DEVELOPMENT and PLANNING SERVICES COMMITTEE

SUBJECT: Variance Permit Application No. VP-476 (Servicing)
 Legal: Lot 2, Section 25, Township 20, Range 10, W6M, KDYD, Plan 3890
 Civic Address: 3820 – 20 Street NE
 Owner: Brautigam, K. & M.
 Agent: Lawson Engineering and Development Services (Blake Lawson)

City of Salmon Arm
Memorandum from the Engineering
and Public Works Department

SUBJECT: Development Variance Permit Application No. VP-477
 Lot A, Plan 6011, Sec. 10, Tp. 20, R.10, W6M, KDYD
 1211 - 20 Avenue SW
 Owner: A. Denter
 Agent: Lawson Engineering & Development Services Ltd. (Blake Lawson, P.Eng.)

CITY OF SALMON ARM			20m R/W Urban Local Road Cross-Section		
No.	Revision	Date	Date	Approved	SPECIFICATION DRAWING No.
A	ISSUED FOR APPROVAL	07/14/16	10-11-2016	 City Engineer	RD-2

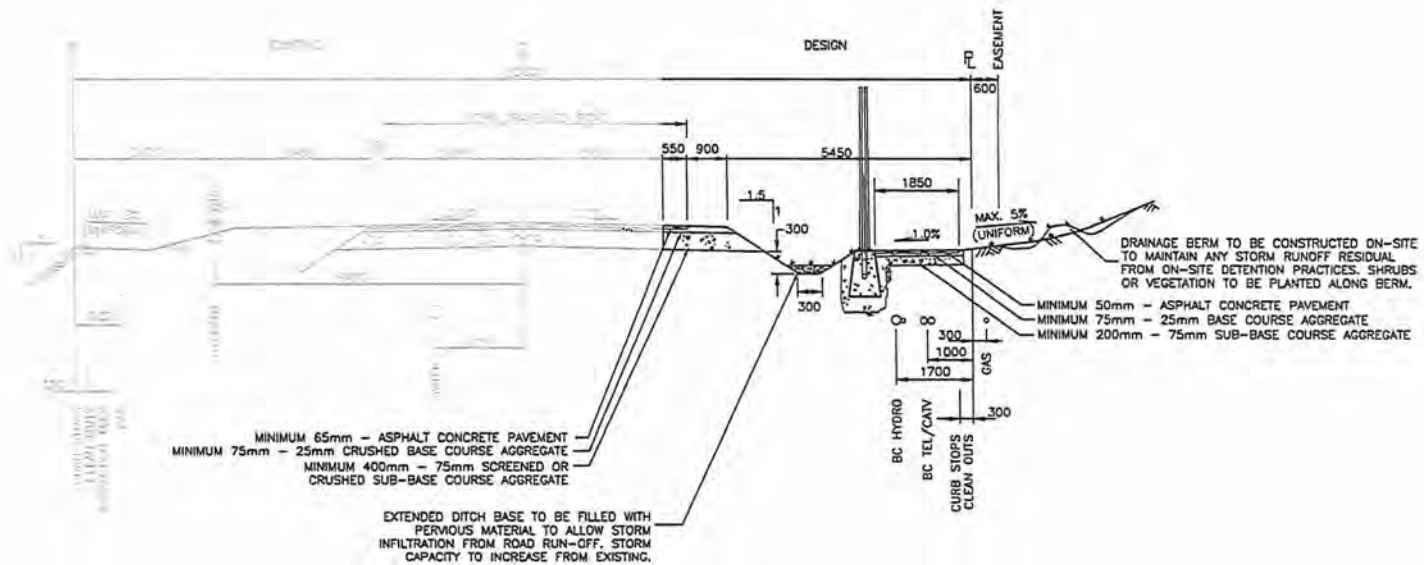
1. Reduce the requirement to construct 20 Street NE to the full Urban Local Road standard, to a modified Urban Local Road design that excludes curb, gutter and sidewalk and includes a ditch and asphalt walkway, as shown on the Lawson Engineering Modified Cross-Section.

20 Street NE is currently constructed to an Interim Local Road standard. Upgrading to an Urban Local Road Standard is required by the Subdivision and Development Servicing Bylaw 4163, in accordance with Specification Drawing No. RD-2. Upgrading may include, but is not limited to, road widening and construction, curb & gutter, sidewalk, boulevard construction, street lighting, fire hydrants, street drainage and underground hydro and telecommunications.

An Urban / Rural Transition Section was approved by Council for similar subdivision properties to the north and south of the subject property (**Laitinen and Green Emerald**) through Variance Permits. The modified urban standard requested would be consistent with these other developments and would ensure that the east side of 20 Street NE has a uniform appearance.

In consideration of the characteristics and rural location and Councils previous approval the proposed modified section on the adjacent subdivision properties; **we recommend that the requirement to construct 20 Street NE to the full Urban Local Road standard be reduced a modified Urban Local Road standard in accordance with the Lawson Engineering Modified Cross-Section.**

CITY OF SALMON ARM			20m R/W Urban Local Road Cross-Section		
No.	Revision	Date	Date	Approved	SPECIFICATION DRAWING No.
A	ISSUED FOR APPROVAL	07/14/16	10-11-2016	<i>[Signature]</i> City Engineer	RD-2

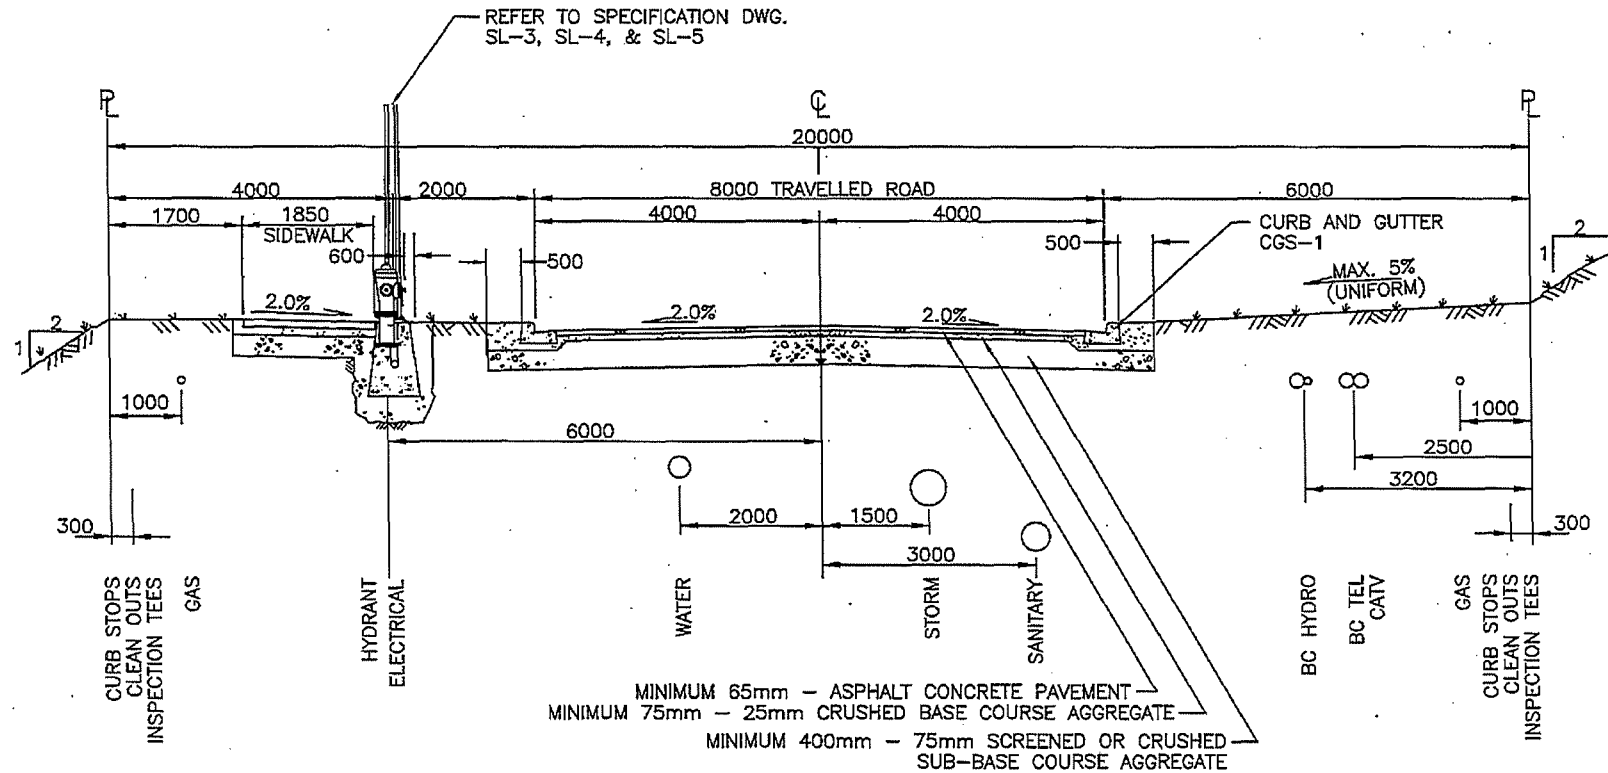
As a condition of subdivision approval, the owner is required to upgrade the north half of the 20 Avenue SW frontage to the Urban Local Road standard in accordance with City of Salmon Arm Specification Drawing No. RD-2. A copy of Specification Drawing No. RD-2 is attached as Appendix 5. At this location, upgrading is limited to road widening and construction, curb & gutter, sidewalk, boulevard construction, street lighting and street drainage. The owner is requesting that the requirement for a sidewalk and street lighting be waived.

1. Reduce the requirement to construct 20 Street SW to the full Urban Local Road standard, to a modified Urban Local Road design that excludes concrete sidewalk, ornamental street lighting.

20 Avenue SW is currently constructed to an Interim Local Road standard. Upgrading to an Urban Local Road Standard is required by the Subdivision and Development Servicing Bylaw 4163, in accordance with Specification Drawing No. RD-2. Upgrading may include, but is not limited to, road widening and construction, curb & gutter, sidewalk, boulevard construction, street lighting and street drainage.

20 Avenue SW currently has no sidewalk but is increasingly being used by pedestrians from "The Ridge" subdivision as a connector to 10 Street Sw. The sidewalk on 10 Street SW will by the end of this year be constructed across 90% of the frontages from 20 Avenue SW to 10 Avenue SW, encouraging a further increase in pedestrian traffic. Further potential subdivision properties may also add to the traffic on this road. The provision of a sidewalk on 20 Avenue SW will provide a safe route for pedestrians to 10 Street SW who are currently sharing the road with vehicles.

20 Avenue SW currently has only 2 street lights, mounted on the BC Hydro poles and is well below the current standard of lighting required by the bylaw. The appropriate level of street lighting is required to ensure the safety of both vehicular and pedestrian traffic and is increasingly important as traffic flows increase due to the development of surrounding properties.

In consideration of safe pedestrian movement along 20 Avenue SW; the Engineering Department recommends that the request to reduce the requirement to construct 20 Street SW to the full Urban Local Road standard, to a modified Urban Local Road design that excludes concrete sidewalk, ornamental street lighting be denied.
